A585 Windy Harbour to Skippool Improvement Scheme

TR010035

8.3 Draft Statement of Common Ground with the Environment Agency

**STATEMENT OF COMMON GROUND WITH THE
ENVIRONMENT AGENCY**

Figure 2-2: South headwall plan

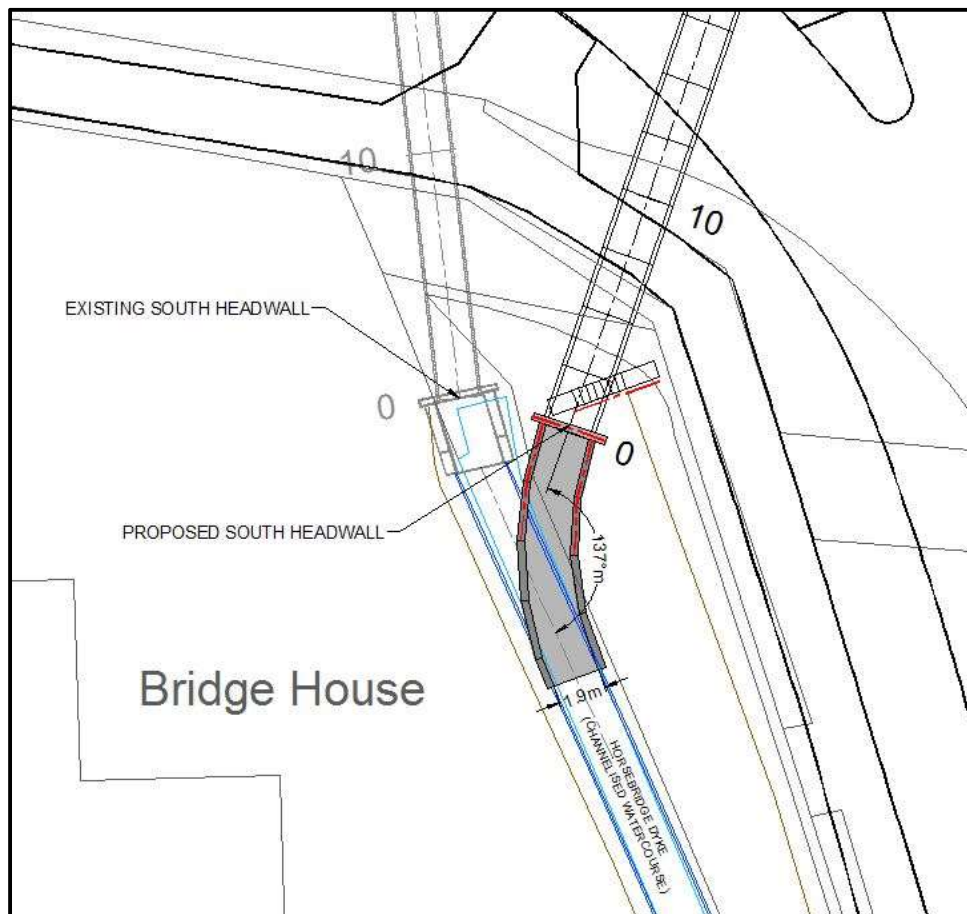
- 2.5.1 The watercourse upstream of the culvert is currently within a masonry lined channel with a concrete base. The proposed culvert would include a new headwall and its wing walls would be of similar construction. The concrete apron upstream of the headwall would connect to the existing concrete channel base that would resist scour (Figure 2-2).

Figure 2-3: North headwall plan

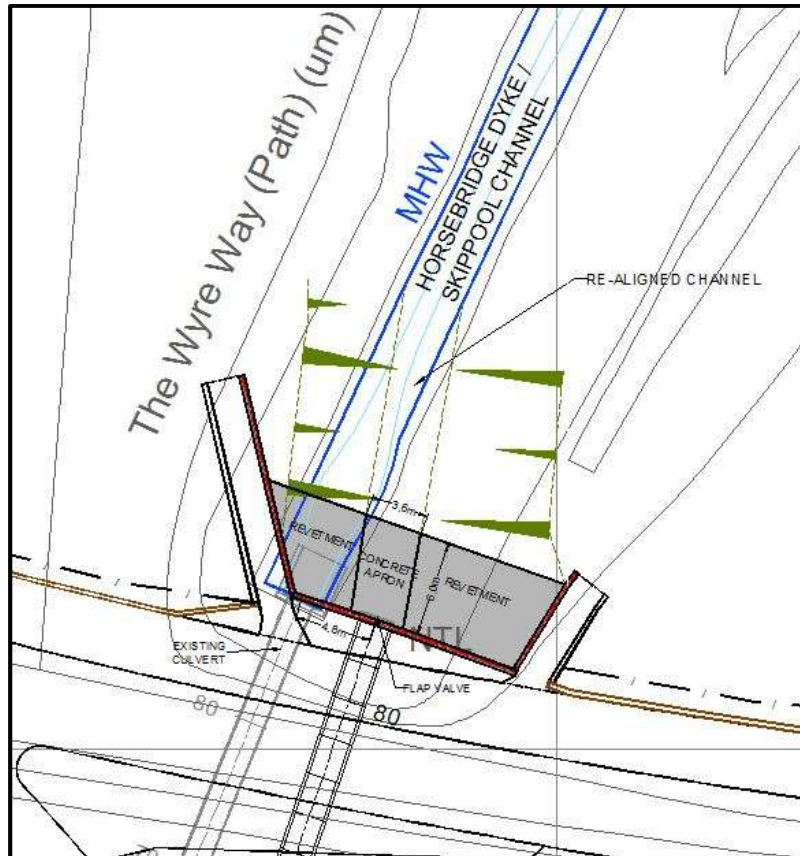
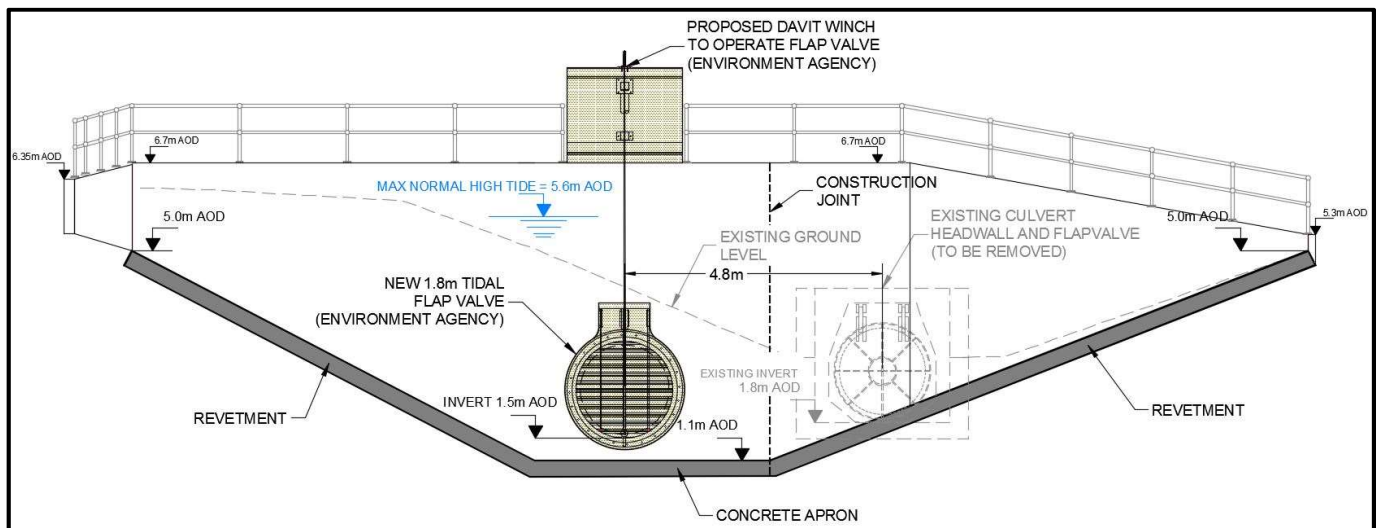
- 2.5.2 It is understood that the Environment Agency is concerned that the preliminary design for the proposed outfall from the new culvert would be offset from the existing culvert outfall by approximately 4.8m (Figure 2-3).
- 2.5.3 The layout of the north headwall has been modified to provide improved access to the Wyre Way on both sides of the watercourse and the height of the main headwall increased to 6.7m for tidal flood protection (Figure 2-4).
- 2.5.4 In respect of scour protection and resilience to the tidal flow conditions in this location, it is proposed that a concrete apron and revetments either side of the apron would be provided and this would extend for about 6m in front of the headwall, allowing the apron to link to the existing watercourse channel. However, this arrangement would be reviewed as part of the detailed design stage and discussed with the Environment Agency.
